PLANNING & ZONING COMMISSION
Regular Meeting
Wednesday, May 18, 2016
6:30 p.m.

TO: Planning & Zoning Commission
FROM: Heather Valone, Village Planner
THUR: Charity Jones, AICP, Planning & Economic Development Director
SUBJECT: Case 15-14 Equestrian Meadows Final PUD
DATE: May 6, 2016

Re: **Equestrian Meadows
Engineering Plan Review No. 1**

Figure 1 The approved Preliminary PUD Engineering plans indicating detention pond B near the Bell Road entrance.

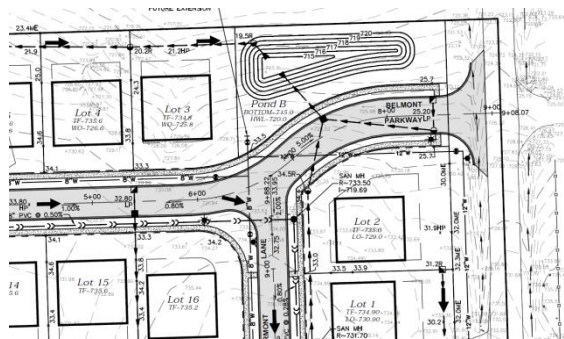
Site Plan. Note that the site plan is substantially conforming to the approved preliminary PUD; however, there are changes that have occurred after the PZC's review in November 2015. The applicant revised the plans to rename the streets along lots 9-2 and 10-16 per the PZC recommendation. The applicant complied with all PZC recommendations. Since Preliminary PUD the applicant has removed detention pond B (Figure 1); however, the

area previously indicated for the detention pond remains open space (Figure 2). The stormwater volume that was proposed to be contained in detention pond B has been rerouted to the two other detention facilities on the site, thus the pond is no longer needed. As the detention pond would have been deeded to the Village, staff sees no issue with the removal of detention pond B.

UTILITY PLAN

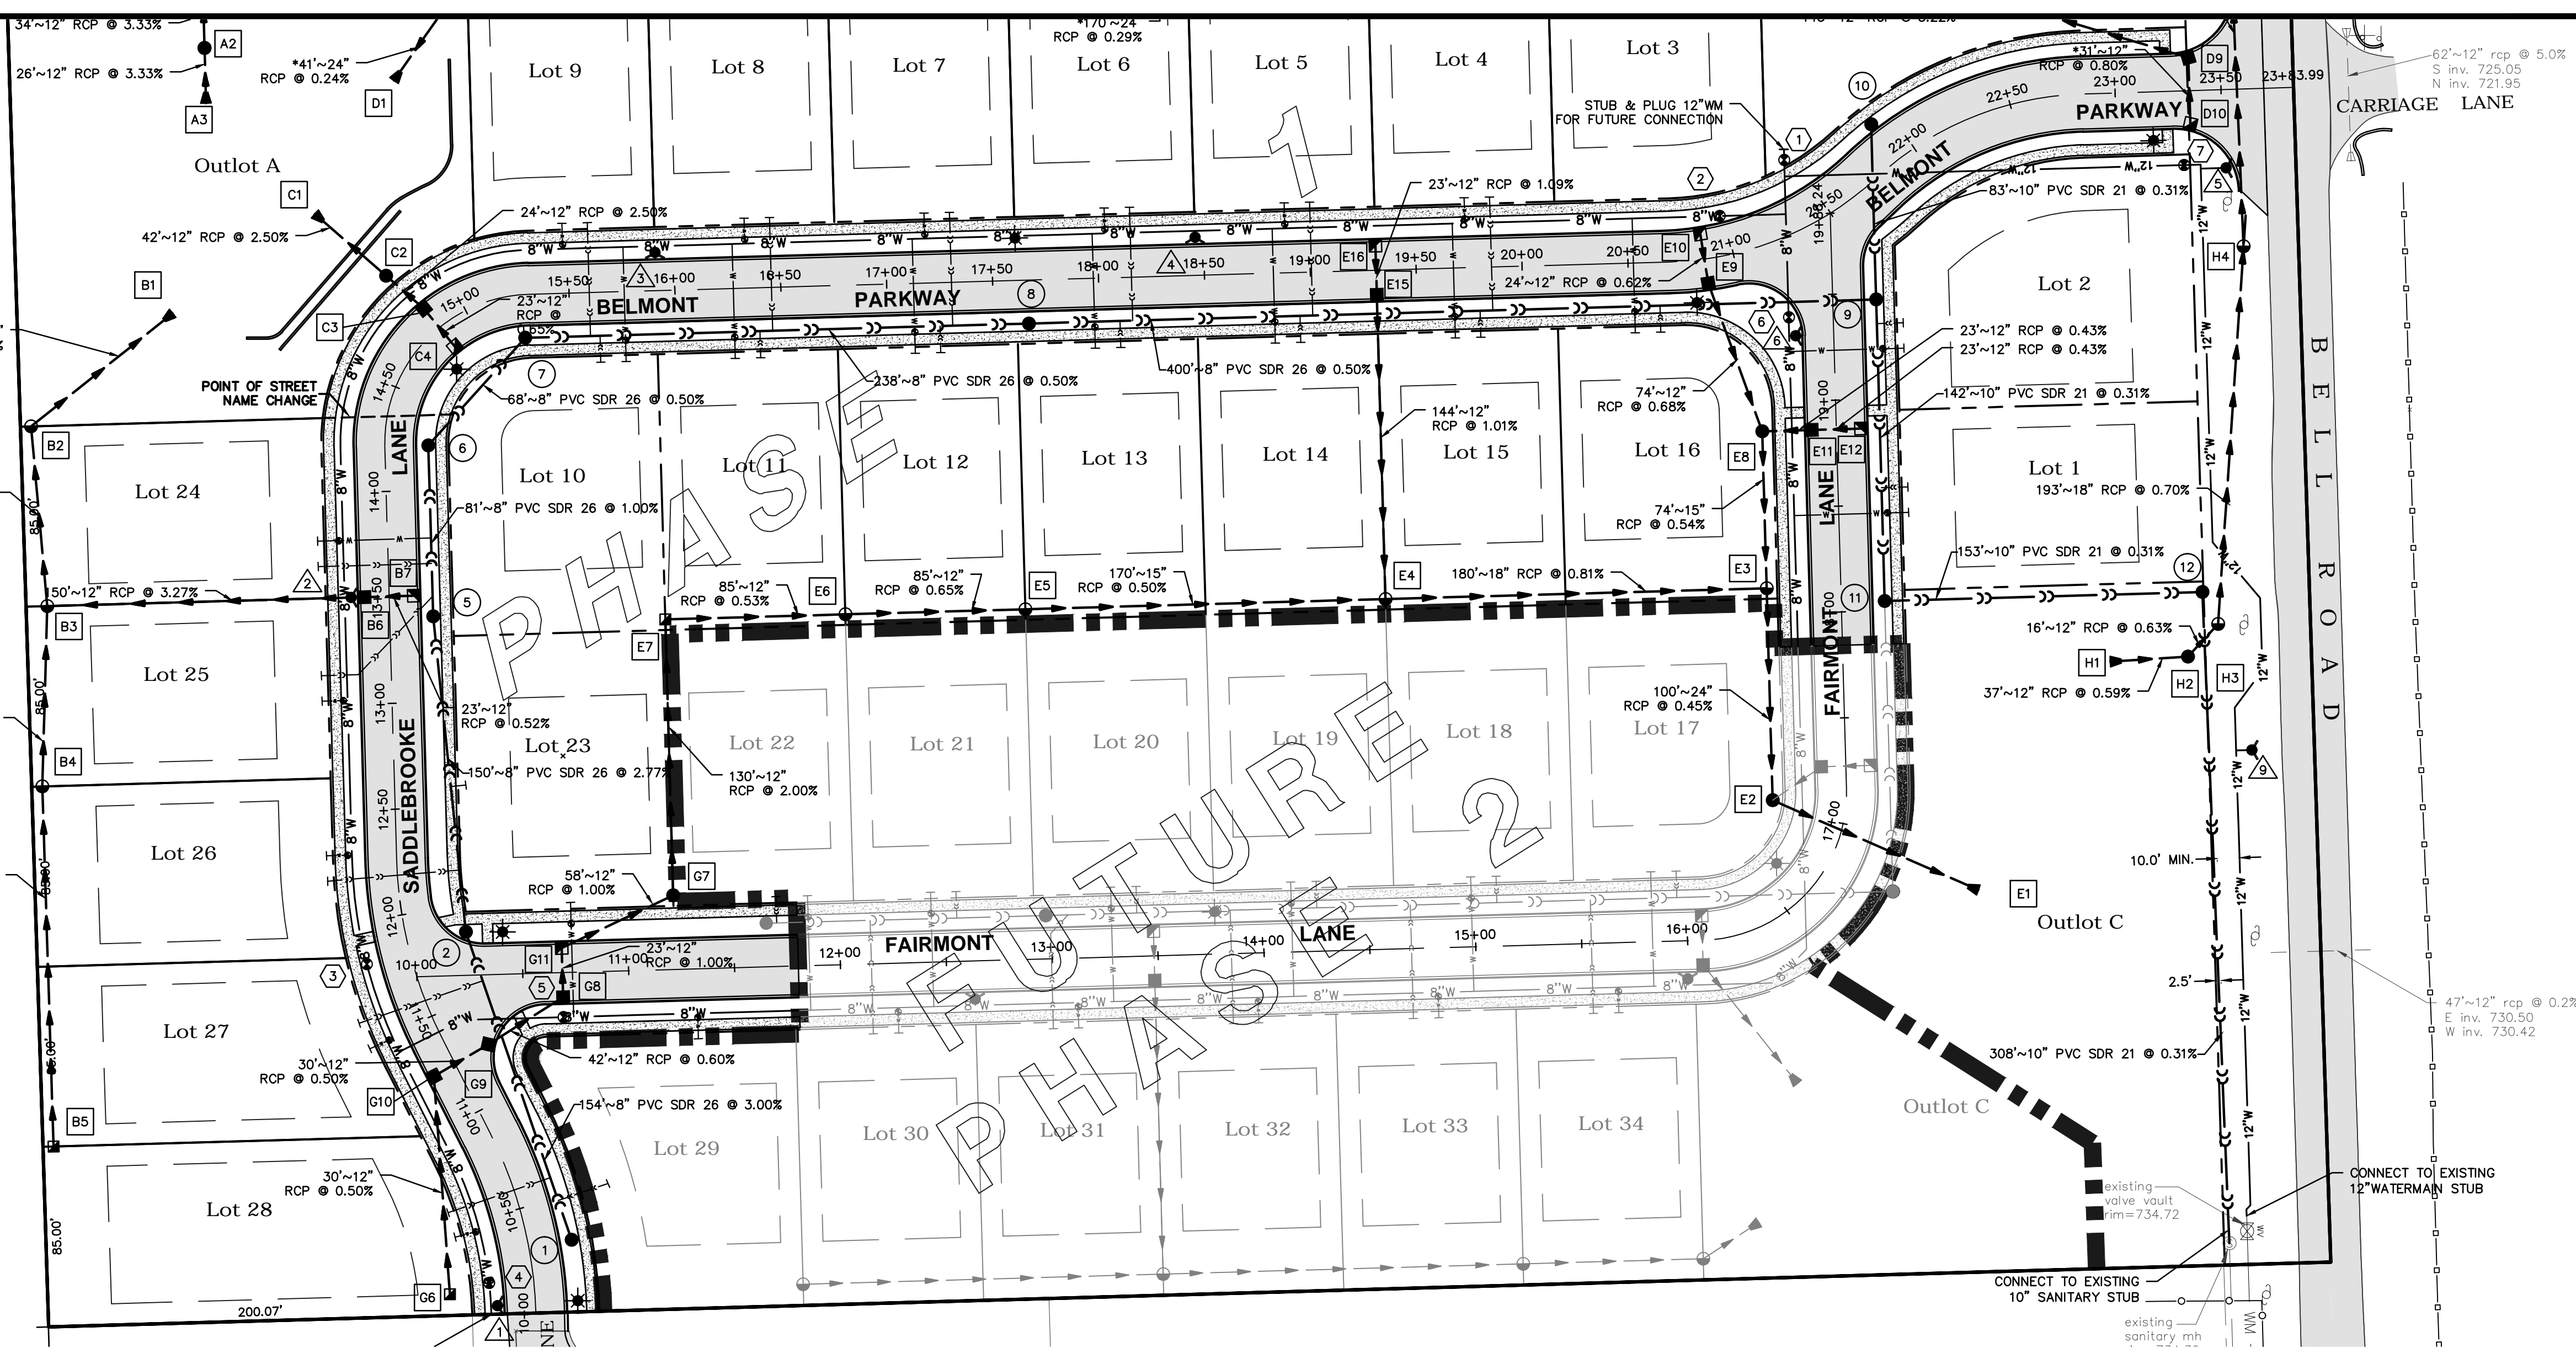
8. One Sheet 9:

- a) Extend the 10-inch sanitary sewer and the 12-inch water main to the north limits of the site, at Bell Road, for future extension. Provide a gate valve in vault and end manhole.
- b) Try to eliminate the 12-inch water main job on Bell Road, at the utility pole.
- c) Structure E4 is very shallow for use of a 48-inch structure. Can you deepen it? This will also help Structures E5 and E6, to avoid rear yard flat top manholes.
- d) Structures E2 and E3 should be 48-inch diameter catch basins.
- e) A 36-inch catch basin is not a standard structure.
- f) Sanitary Manholes 2, 9, 10, 11 and 12 should be 5-foot diameter, due to their depth.
- g) The street light at Fairmont Lane and Saddlebrook drive should be on the west side of the street, to better illuminate the intersection.
- h) Minimum lengths of vertical curves need to use the following values:

PLAN AND PROFILE: SADDLEBROOKE LANE / BELMONT PARKWAY

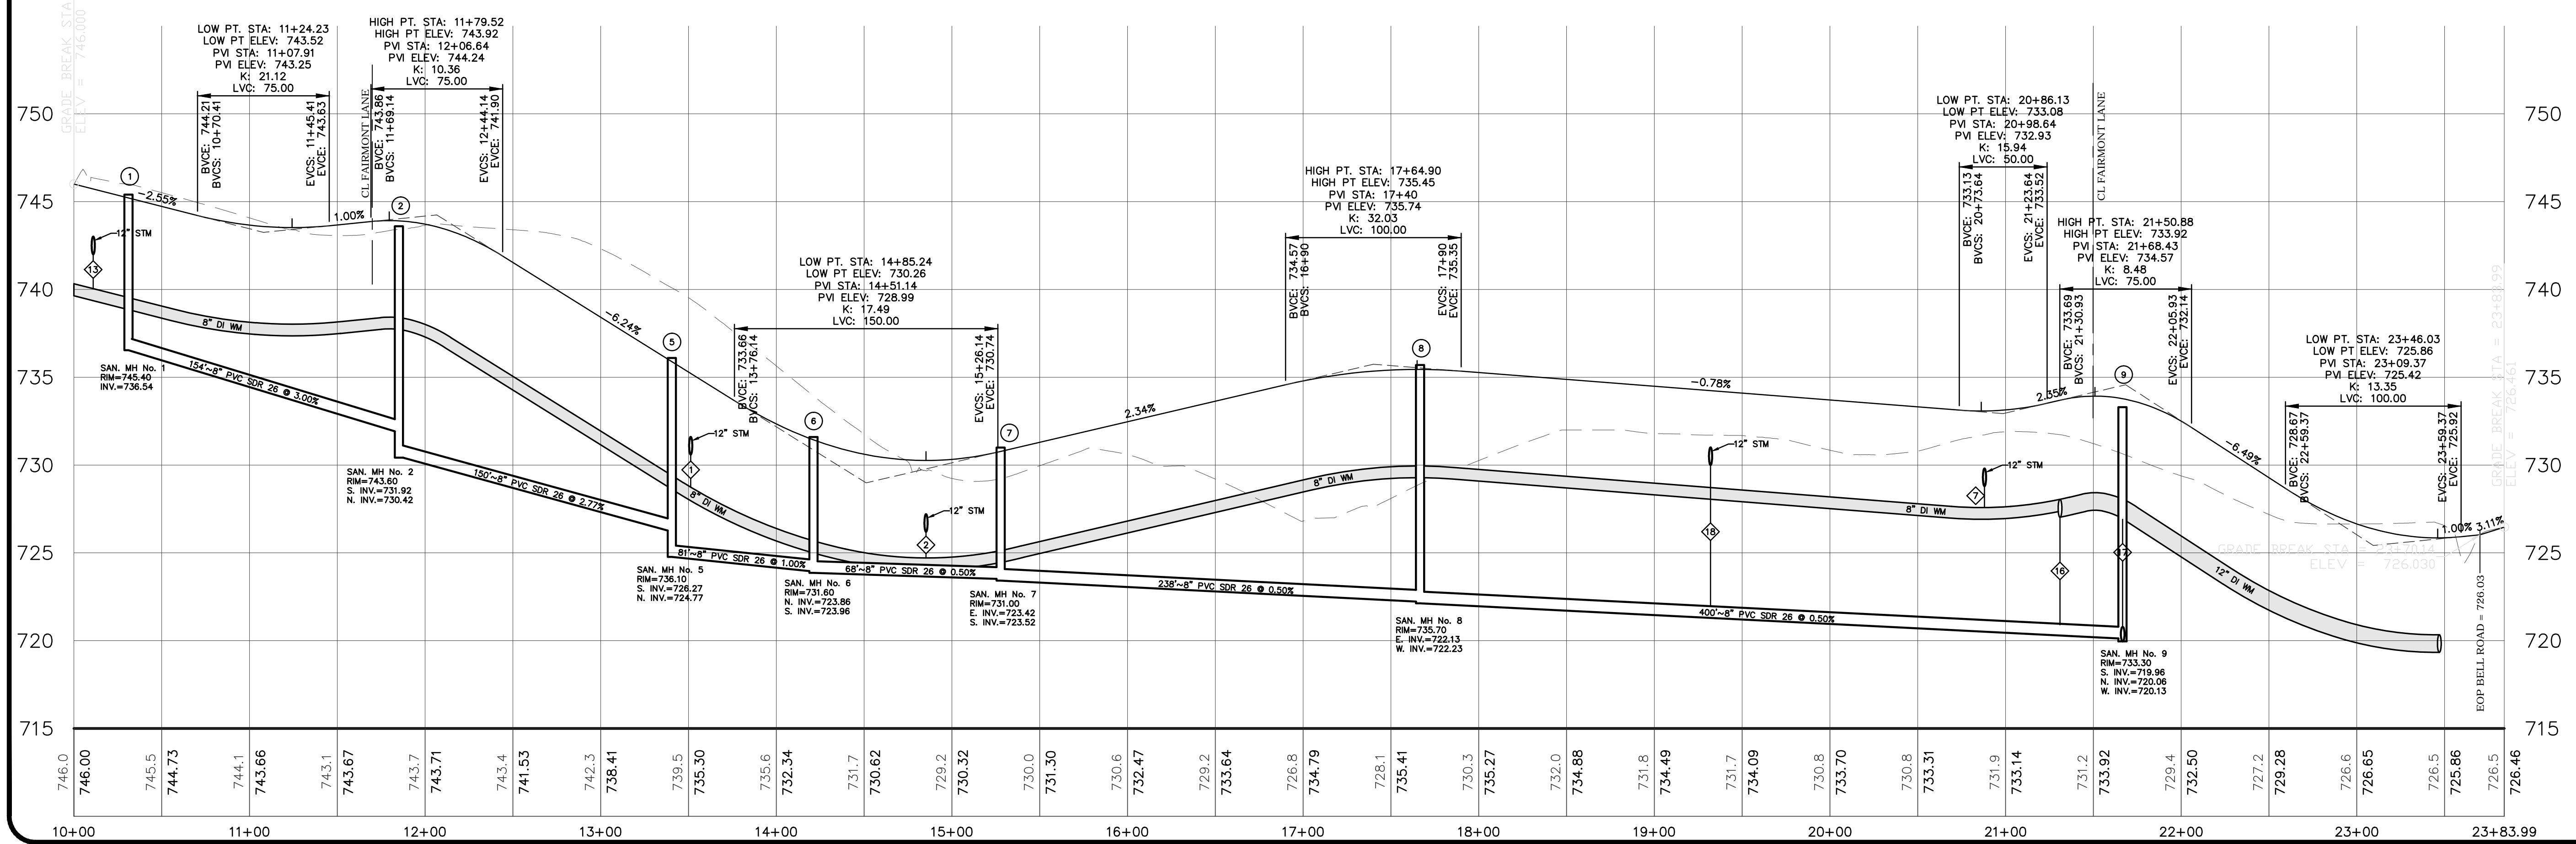
9. On Sheet 11, please make sure that the sanitary sewer on Saddlebrook Lane can be extended (is deep enough) to service all lots in unincorporated Saddlebrook Lane to the south. Terminate sanitary sewer at the property line.
10. Provide a plan note that street signs, street name signs, and parkway trees will be provided per the UDO.
